The Yuba/Feather Work Group (Work Group) is a stakeholder-based collaborative comprised of representatives of local, state, and federal agencies as well as non-profit environmental interests. It was formed to work on flood control and related environmental restoration issues in the Yuba and Feather River watersheds. We would like to share the following concerns with you regarding the Department of Water Resources (Department) activities as they relate to the Federal Energy Regulatory Commission's (FERC) relicensing of the Oroville facilities.

In the Matter of)	October 17, 2005
)	
State of California)	
Department of Water Resources)	Project No. 2100-52
)	
For a New Major License)	
Oroville Division, State Water Facilities)	
"Oroville Facilities")

**MOTION TO INTERVENE
OF
FRIENDS OF THE RIVER
SIERRA CLUB
SOUTH YUBA RIVER CITIZENS LEAGUE**

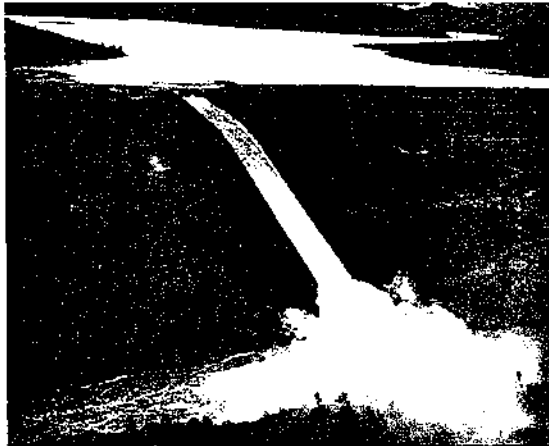
The discharge area below the emergency spillway is not armored and extensive erosion would take place if the emergency spillway were used. The spillway road and possibly high voltage transmission towers would be impacted. (p. II-1) Because the area downstream from the emergency spillway crest is an unlined hillside, significant erosion of the hillside would occur. (p. II-5) "The hillside between the emergency spillway and the Feather River would be subject to severe erosion when water flows over the spillway. Depending on the rate of flow, the erodable area . . . could range from 50 to 70 acres. The amount of soil, rock, and debris that would fall into the Feather River could be very large, depending on the depth of erosion. There could be damages to downstream structures, including the Thermalito Diversion Dam and Powerplant, Fish Barrier Dam, and highway bridges. If there is river channel blockage below the spillway, there could be impacts on operation of Hyatt Powerplant. (p. IV-3)

The *YCWA Technical Memo* did not express any judgement on whether a single operational use or multiple operational uses (with failure to repair any preceding or cumulative damage) of the ungated spillway could result in a loss of crest control of Oroville Dam. A loss of crest control could not only cause additional damage to project lands and facilities but also cause damages and threaten lives in the protected floodplain

Figure 8. Lookdown View. Main spillway gate above (with spillway extending to the right downslope). Ungated spillway below without any downslope spillway. See spillway sections used in figures 6 & 7. ACE, 1970

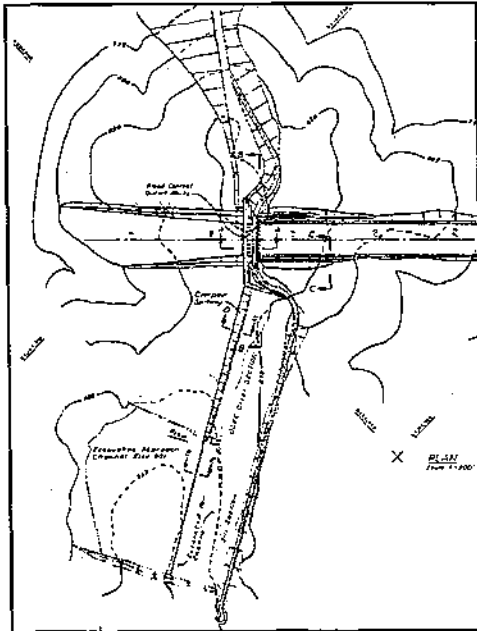
Obviously, a major issue in this relicensing is that the ungated spillway presently has the physical characteristics and consequences of use of an emergency spillway, but the required uses of an auxiliary spillway, imposing on the Commission the duty of requiring modification to the spillway.
